# UNITED STATES PATENT AND TRADEMARK OFFICE

APPLICATION NO.	FILING DATE	FIRST NAMED INVENTOR	ATTORNEY DOCKET NO.	CONFIRMATION NO.
09/971,131	10/04/2001	James C. Tuthill	21488/04040	4066

<b>Office Action Summary</b>	Application No.	Applicant(s)	
	09/971,131	TUTHILL, JAMES C.	
	Examiner	Art Unit	
	Dana Ross	3722

### **DETAILED ACTION**

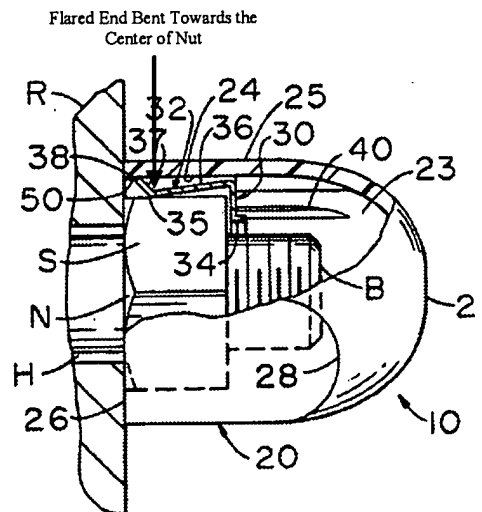
Regarding claim 8, Bias teaches a base (31), peripheral section (32, 36), central aperture (33) wherein the peripheral section includes fingers which define windows (see figures 7 and 9). The fingers each include a “flared end” (see lead lines 37 and 38) “bent” toward the center of the retainer (see figure 3 wherein cap 21 is installed, the ends of the fingers are “bent”).

Regarding claim 13 and 16, Bias discloses a retainer (30) comprising an integral base section (31) and a generally perpendicular peripheral section (32) maintaining a cup-shaped configuration while in place over the nut (N). The base section (31) has a central aperture (33) and the peripheral section (32) has an interior surface that includes a plurality of fingers which define one or more longitudinal windows therebetween (see figures 8A and 9). The fingers having nut-engaging surfaces on the interior surface of the peripheral section (this is shown most clearly in figure 3 above).

Regarding claim 18, in as much structure is set forth in the claims, elements (35) and (37) qualify as "lobes."
